Site Audit Report 278_PREW by Dr Ian Swane

WESTCONNEX STAGE 3A PREW WORKSITE (AREAS C1B & C3B)

PARRAMATTA ROAD, ASHFIELD

Final | 22 NOVEMBER 2022

Figure 2-9 Location and Depth of Fill Across PREW site

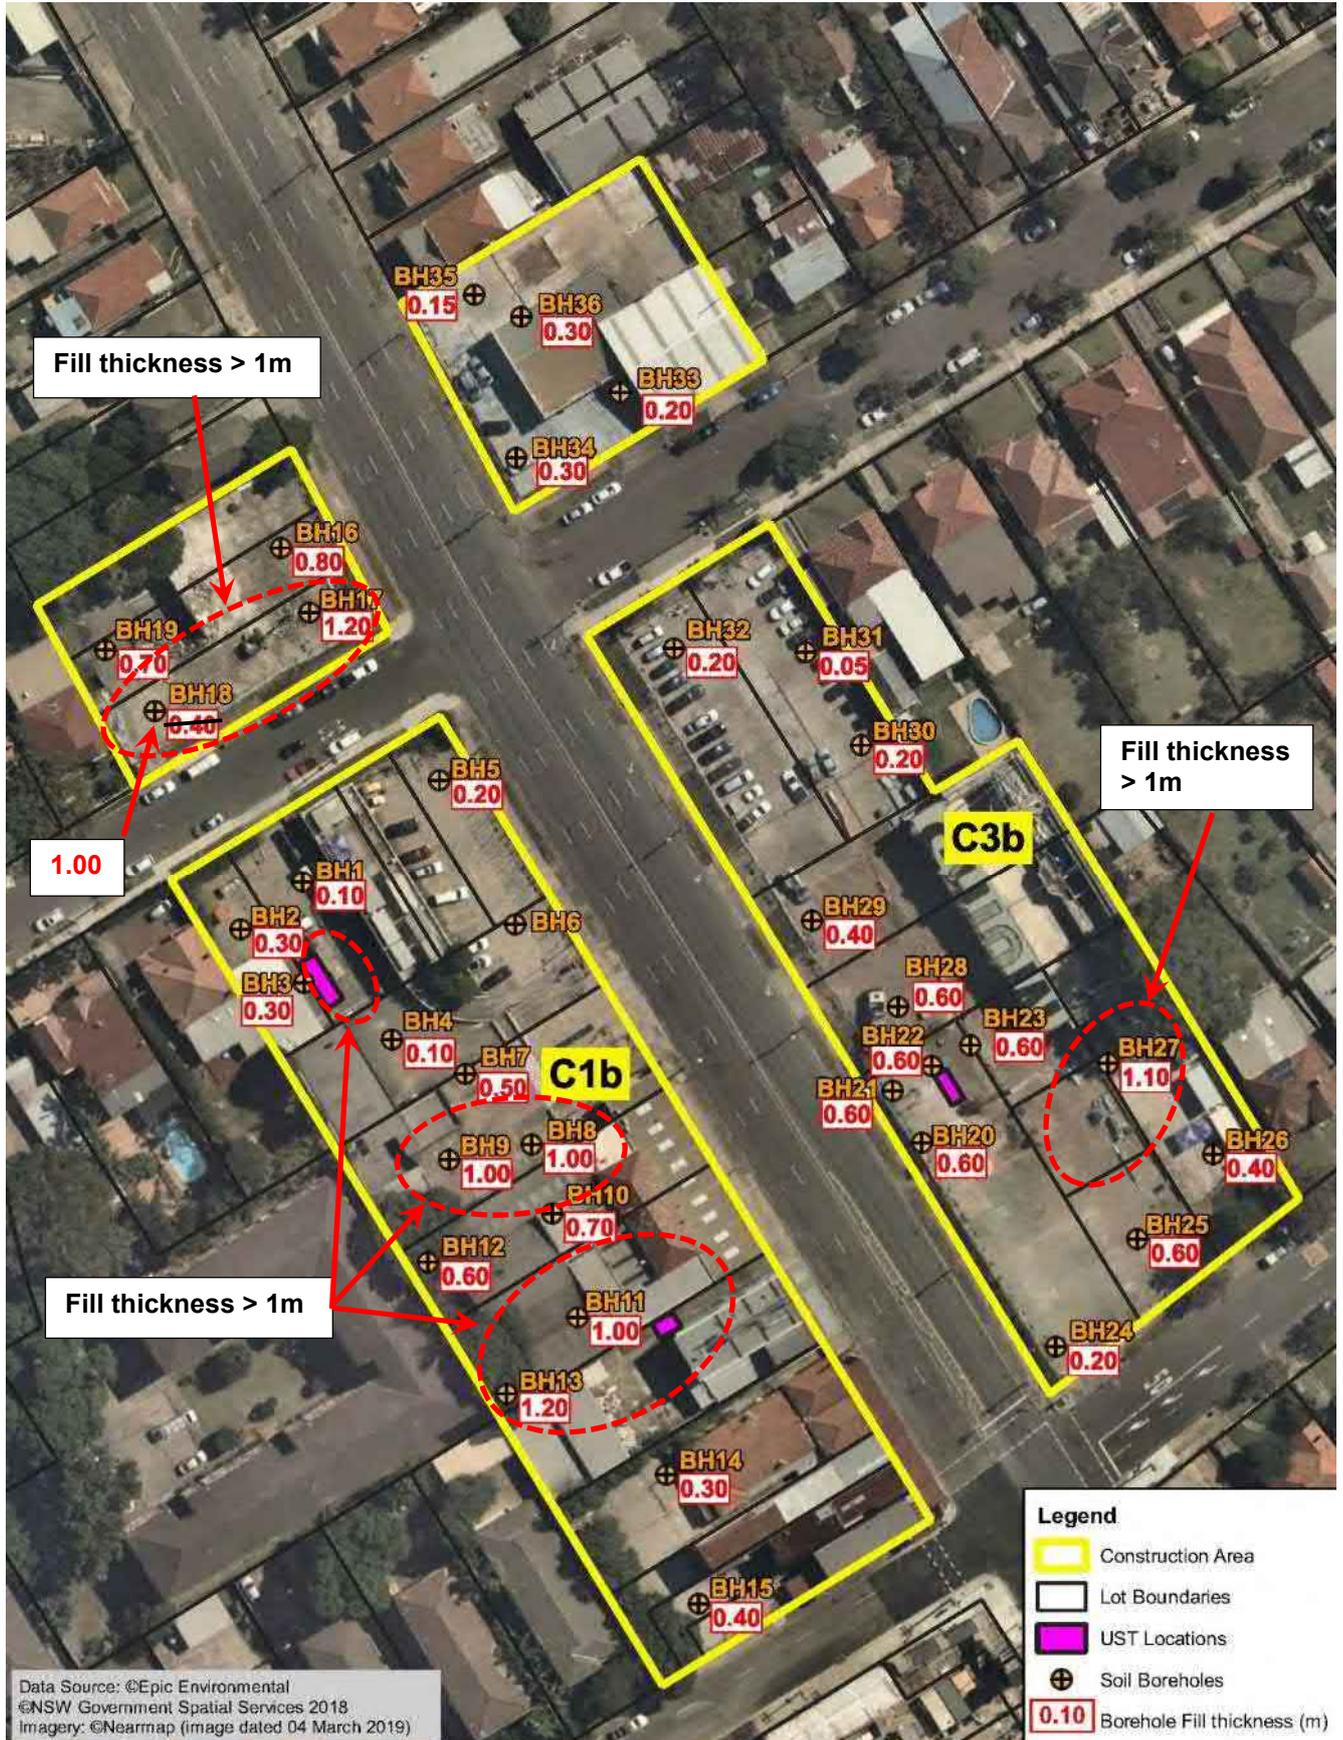
- The borelog for BH18 showed fill to extend to a depth of 1.2 mbgl but Figure F7 incorrectly showed fill extended to a depth of 0.4 mbgl.
- In Table T1:

3. Section 8: Site-specific background levels for metals in soils were not derived.
4. Figures:
 - a) Figure F7: The fill thickness at BH18 should be 1.1m based in the borehole log data; and

Figure 3-4 Locations of USTs Removed from PREW site

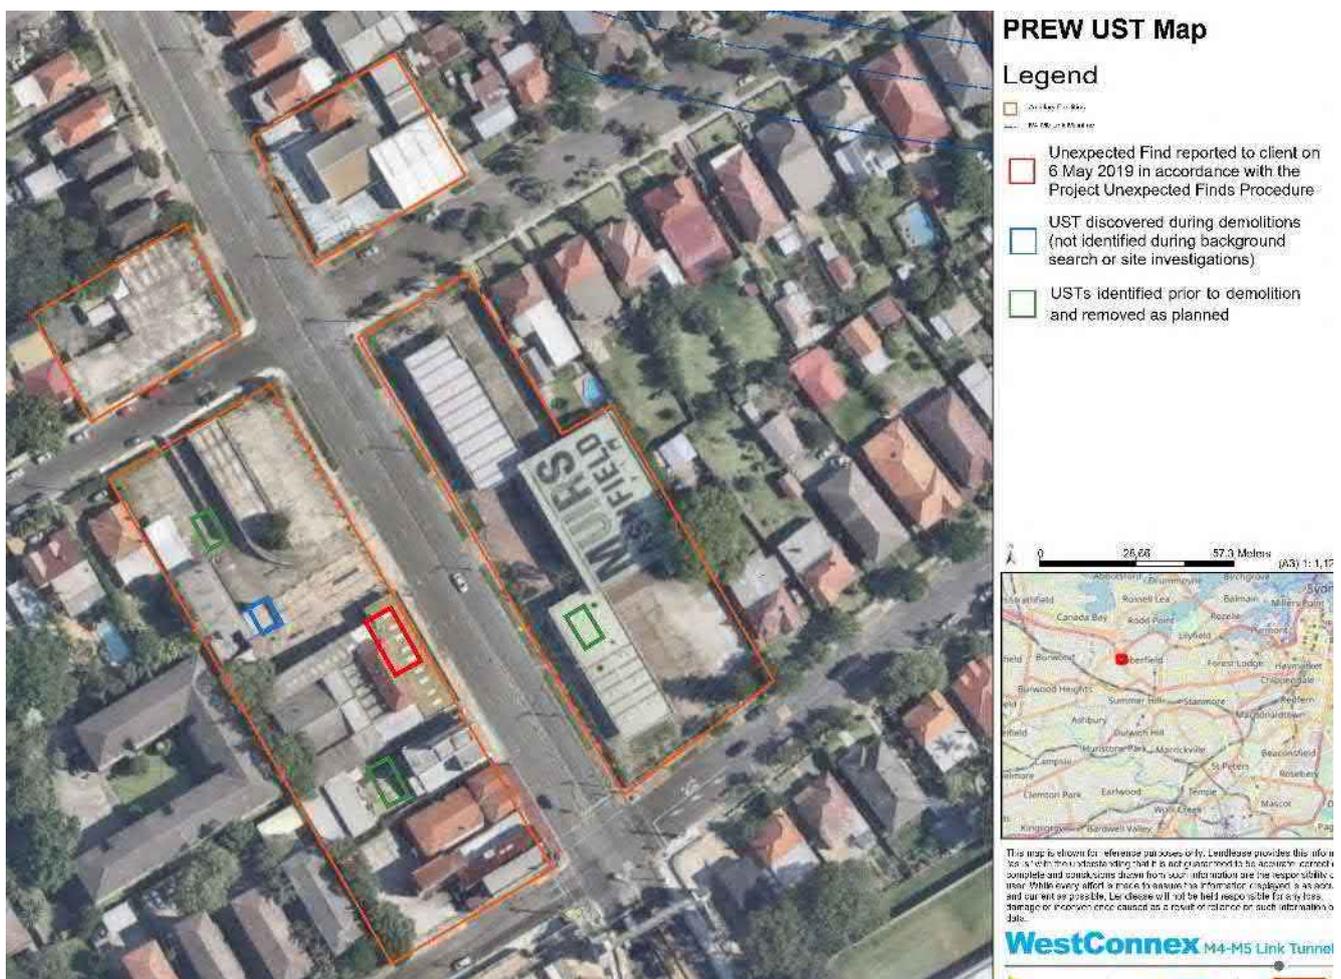
- The Epic 2019 DSI did not identify all USTs present at the Site, since it only identified four USTs that needed to be removed whereas the ASBJV plan (**Figure 3-4**) showed five areas where USTs were removed. The ASBJV site engineer also advised that Site Auditor at the 4/11/22 site inspection that more than one UST was present at some of the areas where USTs were removed;
- During a site inspection conducted by the Site Auditor on 4/11/22, the ASBJV site engineer advised that more USTs were removed from the Site than the four USTs identified by the Epic 2019 DSI, as previously described in **Section 2.3**;
- No methodology was provided showing how ASBJV identified USTs at the Site; and

Figure 3-9 Fuel Fill Point Remaining in Area C1b on Western Side of PREW Site

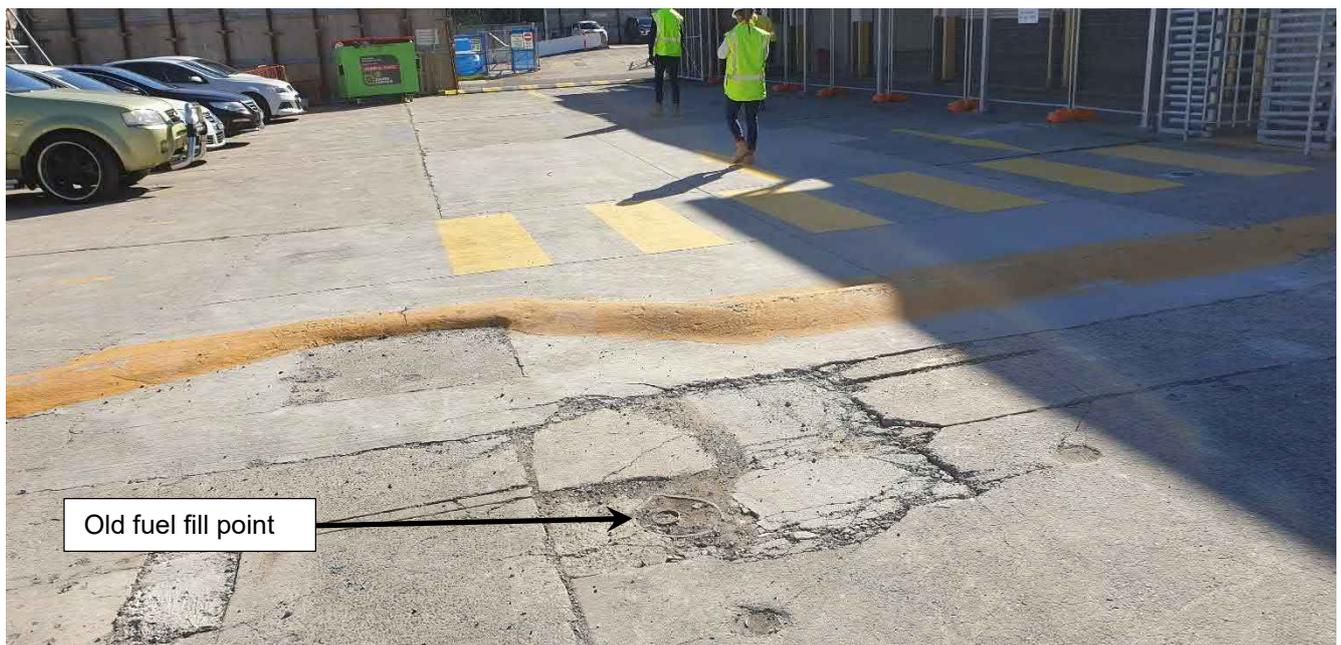
The Site Auditor also found that some fuel fill points and belowground fuel pipelines associated with removed USTs remained at the Site when inspecting the PREW site on 2/06/11 and 4/11/22, as shown by the photo provided in **Figure 3-9**. There was a risk that localised petroleum hydrocarbon contamination may remain around this buried infrastructure. The Site Auditor has assessed the significance of this risk in **Section 3.4.4**.
